Date: September 18, 2023

Facility Name: Beck Landfill

Permit or Registration No.: 1848A

Municipal Solid Waste Permit Amendment No. 1848A
 Beck Landfill
 Fourth Notice of Technical Deficiency

DRAWING NO. **1-5**
 SHEET 1 OF 1

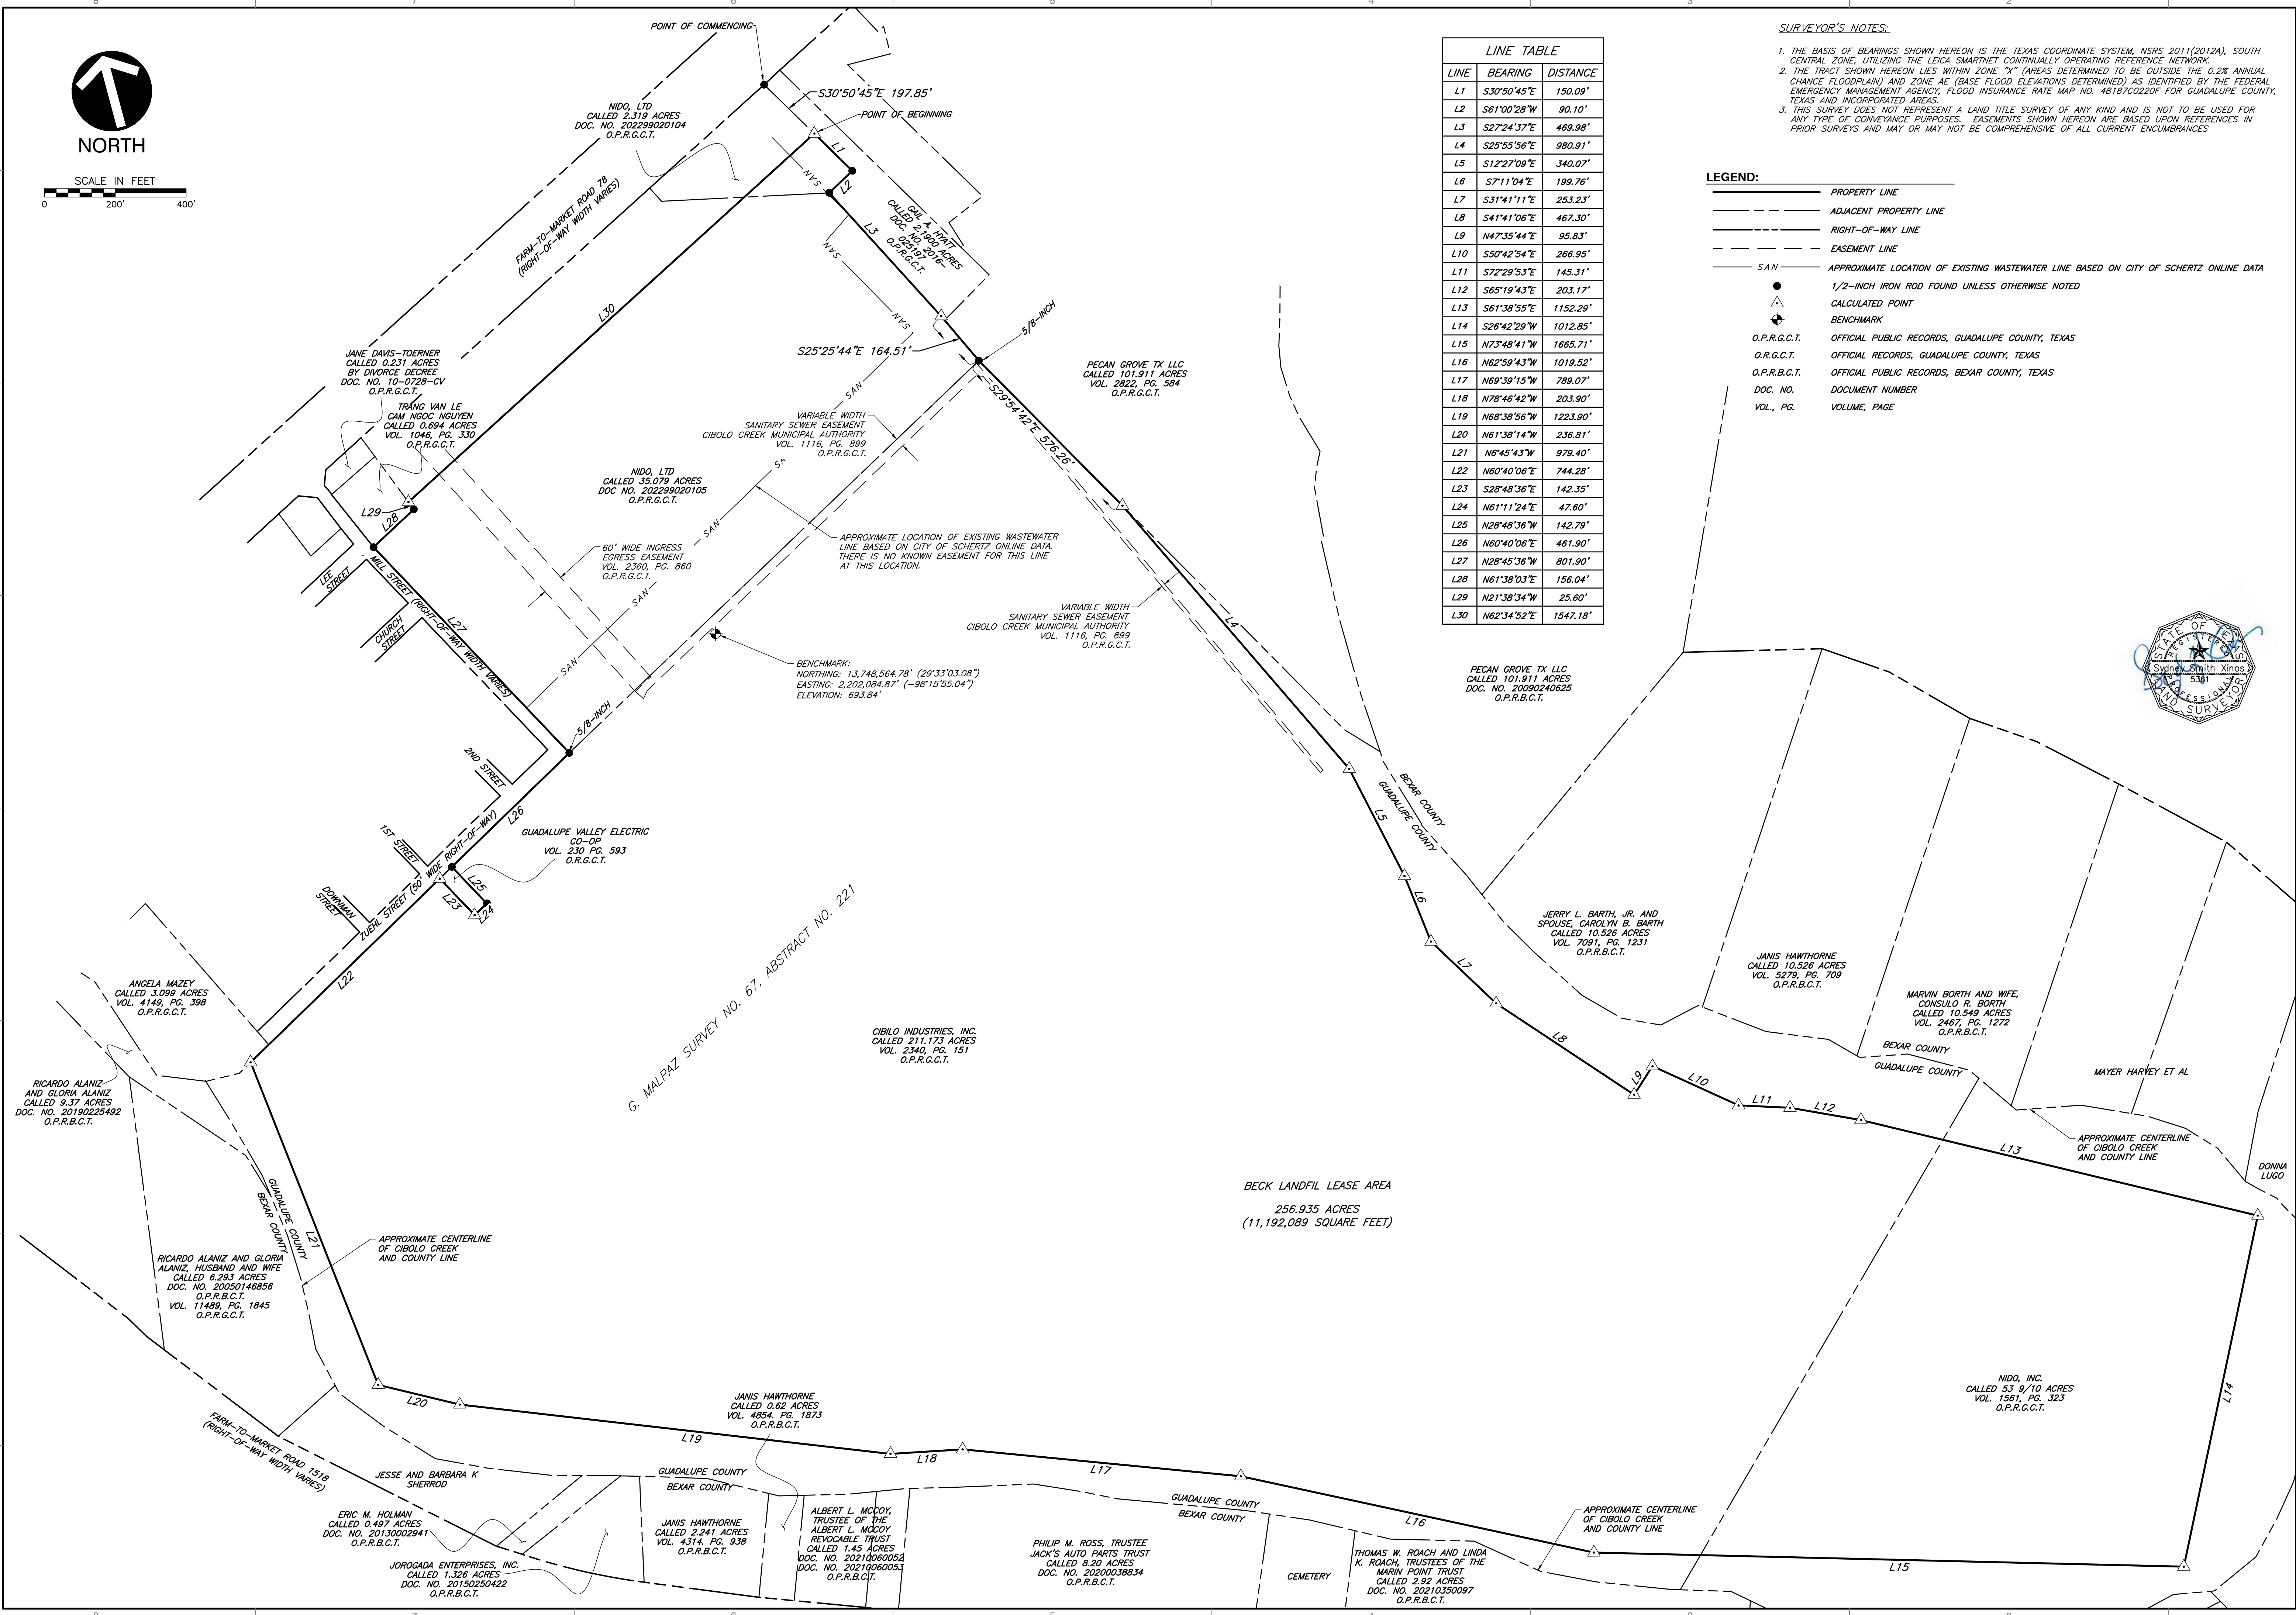
NOD ID	MRI ID	App. Part	Citation	Location	NOD Description	
1	2 and 849	Part I	330.59(b) and 330.143(b)(8)	Part I Form, Section 12	Revise the Part I form, Section 12, to correct the benchmark location and elevation. Drawing I-5, Lease Boundary Survey, dated June 30, 2023, indicates at the benchmark moved north 13,748,565.11 feet and east of 2,202,086.12 feet. Permit 1848 indicates the benchmark location is 702.9ft and the elevation is 775ft. Indicate if the benchmark location is changing.	The benchmark location is changing from the one shown in permit 1848. The Part I form and several figures in Part I and Part II have been updated to accurately reflect the new benchmark location.
2	85	Part I	330.59(d)	Part I, Attachment 5 (Section 5 in initial application and NOD1 response)	Clarify the acreage within the permit boundary and provide a revised legal description. The legal description dated August 29, 2022, in the initial application and response to the first notice of technical deficiency (NOD) indicated 256.935 acres. The legal description dated July 19, 2022, in the response to the second NOD indicates 266.474 acres.	The correct acreage is 256.935 acres. An older version of the legal description was mistakenly included with the 2nd NOD response. The correct legal description has been provided with this response.

3	849	Part I	330.59(b) and (d), and 330.143(b)(8)	Part I, Attachment 5 (Section 5 in initial application and NOD1 response)	Revise Drawing I-5, Lease Boundary Survey, to indicate the correct latitude and longitude that corresponds to the change of the benchmark location found in the Part I form, Section 12. The revised drawing must include the surveyor's seal, signature, and signature date.	A revised version of Drawing I-5 has been provided with an updated Lat/Long for the benchmark.
4	12	General	330.57(d)	Parts I through IV	Correct references to the facility permit number to indicate 1848A, instead of 1848.	Corrected as observed. Please provide any missed references if found.

DRAWN BY:	MFV	CHECKED BY:	AWM	APPROVED BY:	AWM	FIGURE NO.:	C3-1
DATE:	08/2022	DWG SCALE:	1" = 100'	PROJECT NO.:	311-653

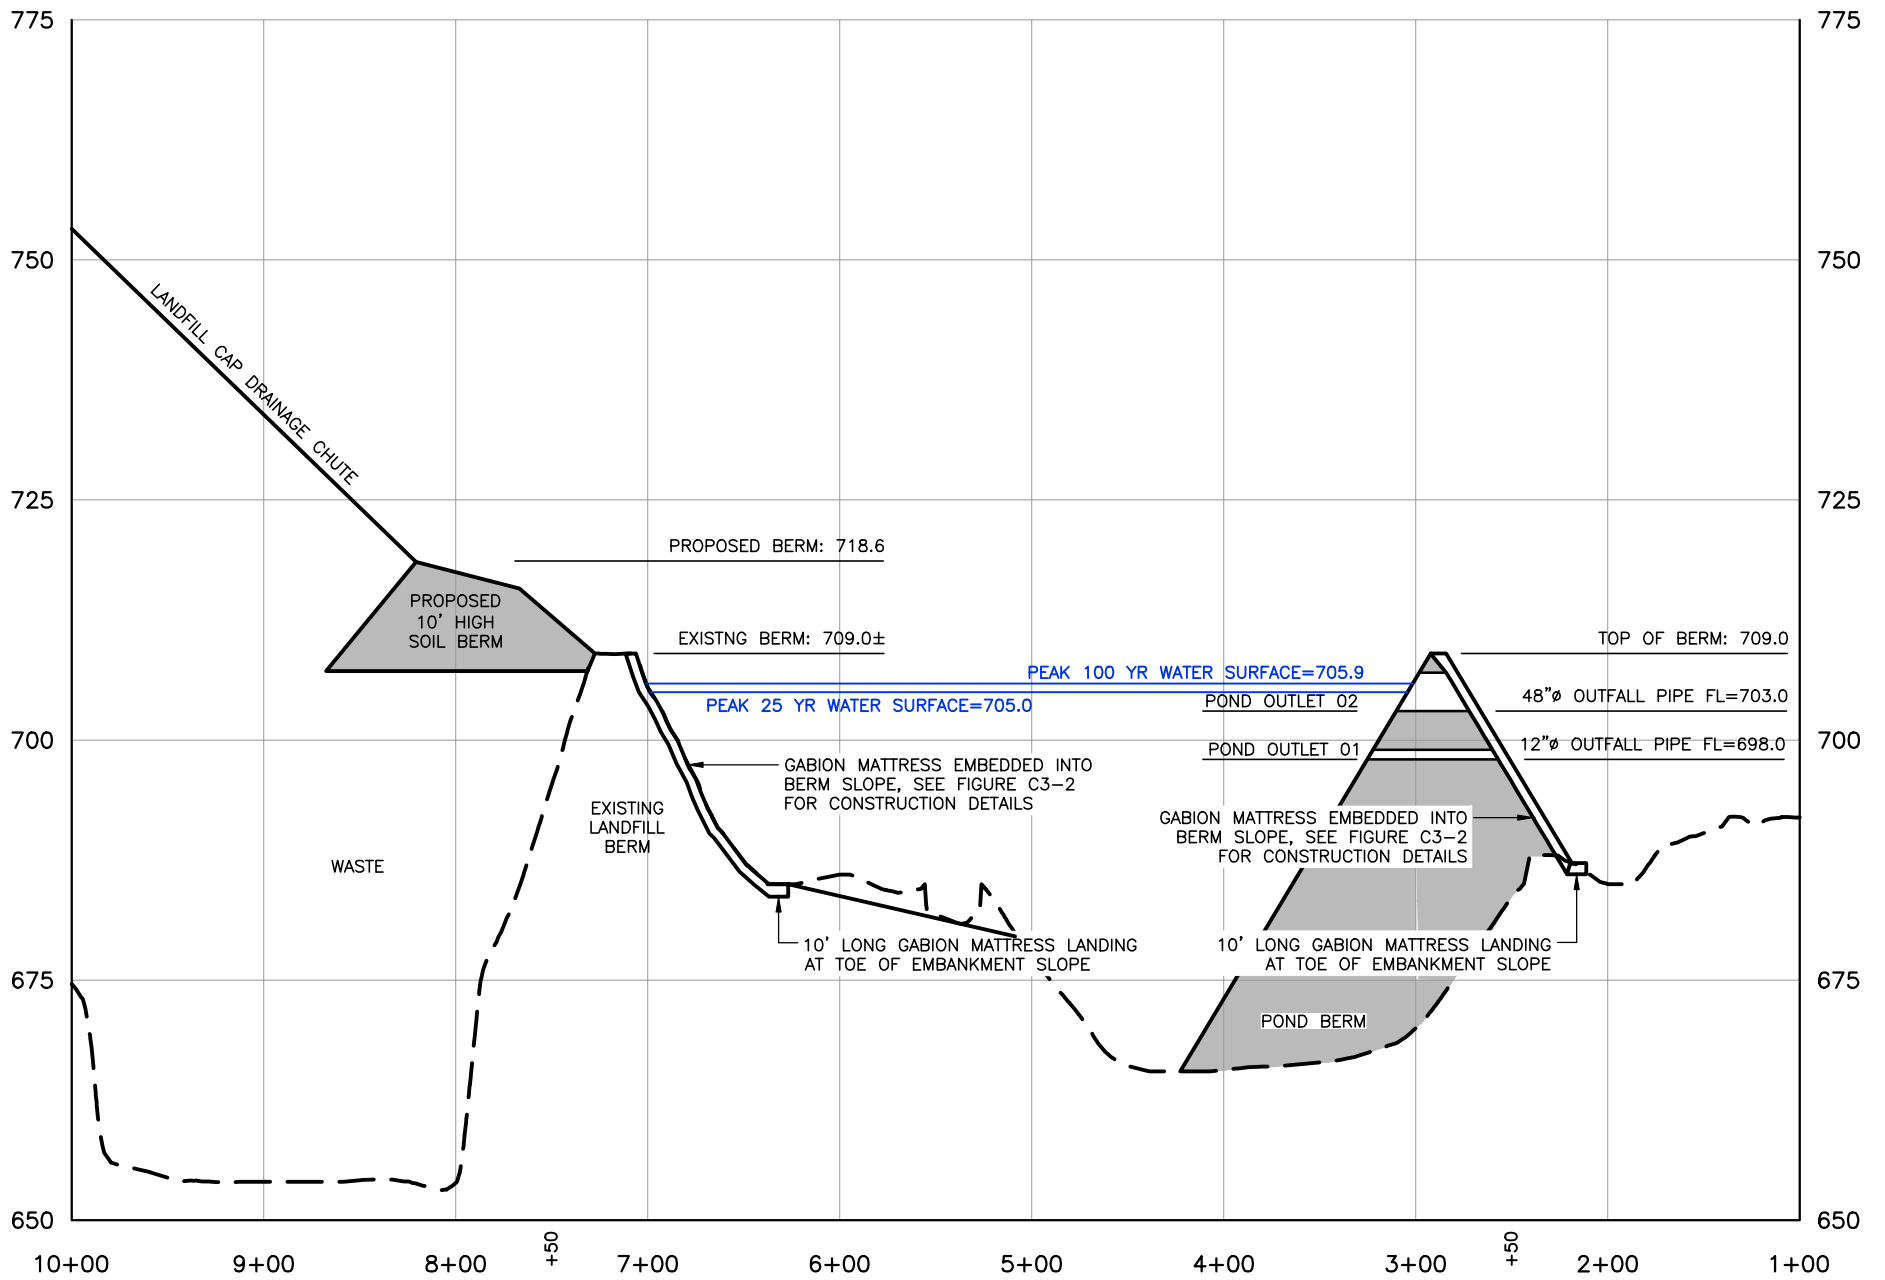
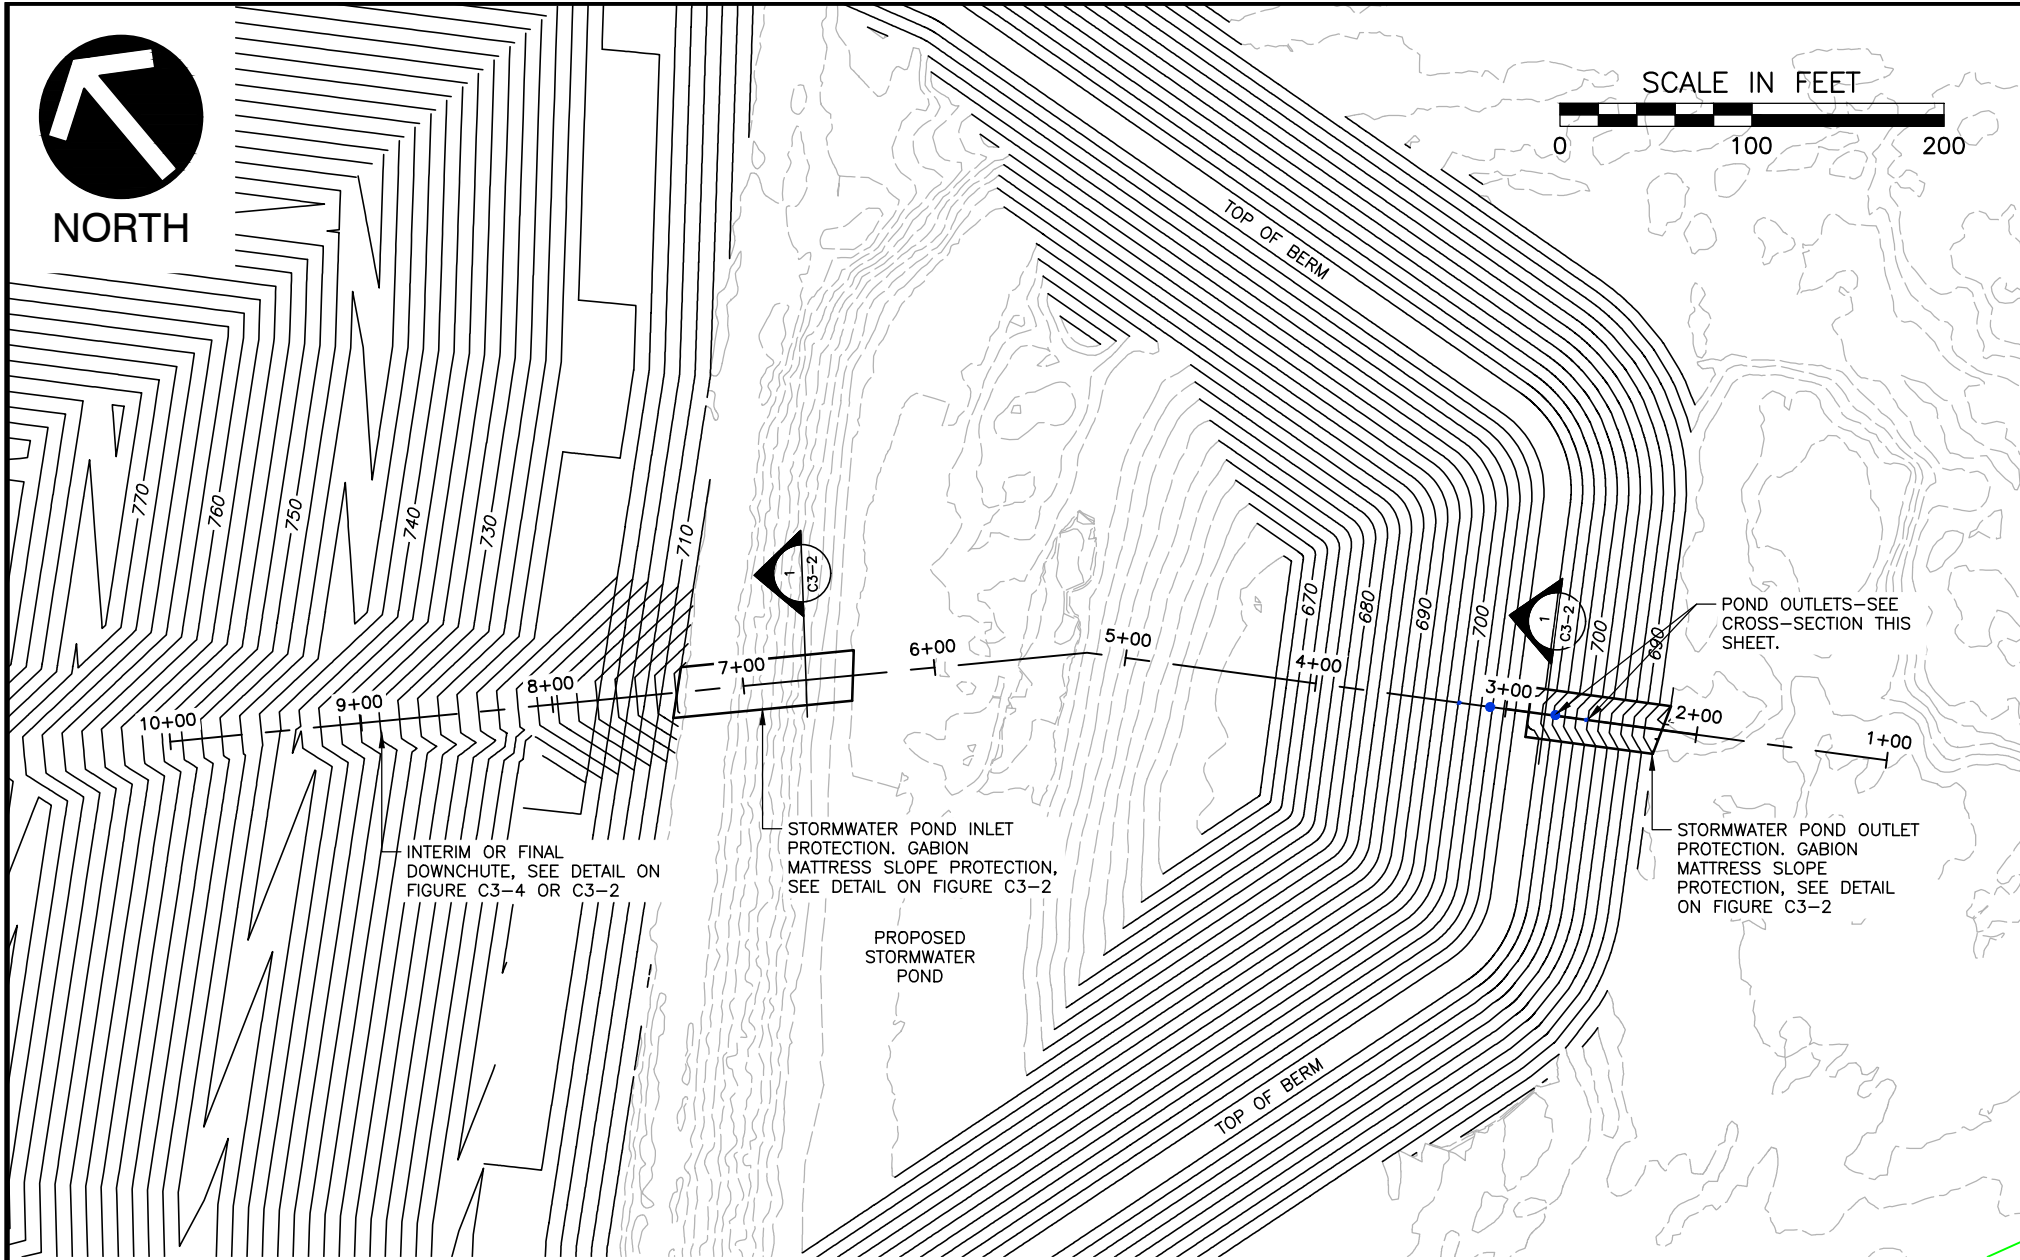
NOD ID	MRI ID	App. Part	Citation	Location	NOD Description	
12	298	Part III	330.305(e)	Appendix C1-F	(a) Revise Appendix C1-G to provide cross-sections for berms/benches on the slopes, letdowns, perimeter berms, and detention ponds/sedimentation basins for an interim phase of landfill operation. Provide dimensions and construction specifications on drawings for each of the cross sections. (b) Include reference materials in the application used for soil loss calculations in Universal Soil Loss Equation by Natural Resource Conservation Service of the United States Department of Agriculture.	Figure C3-4 has been added to Appendix C3 to provide typical details for the proposed interim drainage controls.
13	311	Part III	330.63(c)(1)(D)(ii) and (iii)	Appendix C1-B and Appendix C1-C	(a) Provide a drainage plan, including details of stormwater collection system for Sub-drainage Area, DA-P09 (35.9 Acres). (b) Identify pond outlets #1 and #2, and a cross-section mark on Figure C3-1 to match Figure C3-2 (Stormwater Pond Inlet /Outlet Channel Protection). Also, provide design calculations for outlets #1 and #2, and include cross sectional details of the outlets. (c) Indicate the detention pond layout plan, including inlets and outlets on Figure C1-2.	a) Drainage area DA-P9 has been added to the proposed HEC-HMS calculations and the comparison tables have been adjusted in Attachment C and Appendix C-1 to reflect this correction. There are no improvements proposed in this area and the entire area is inundated by Cibolo Creek in the 24-hour, 25-year event. b) The pond outlets have been labelled on Figure C3-1. Design calculations are included in Appendix C1-C, starting on Page 9. A cross-section through the outlets has been added to Figure C3-2. c) The detention pond has been labeled on Figure C1-2 as requested.

14	313	Part III	330.63(c)(1)(D)(iv)	Appendix C1-D and C1-E	Provide structural design/drawings, including cross-sectional details for the proposed drainage structures (e.g., berm/benches on slopes, chutes, perimeter berms, intersections of chutes and berms, toe of chutes, ponds, etc.) for an interim phase of landfill operation.	Figure C3-4 has been added to Appendix C3 to provide typical details for the proposed interim drainage controls.
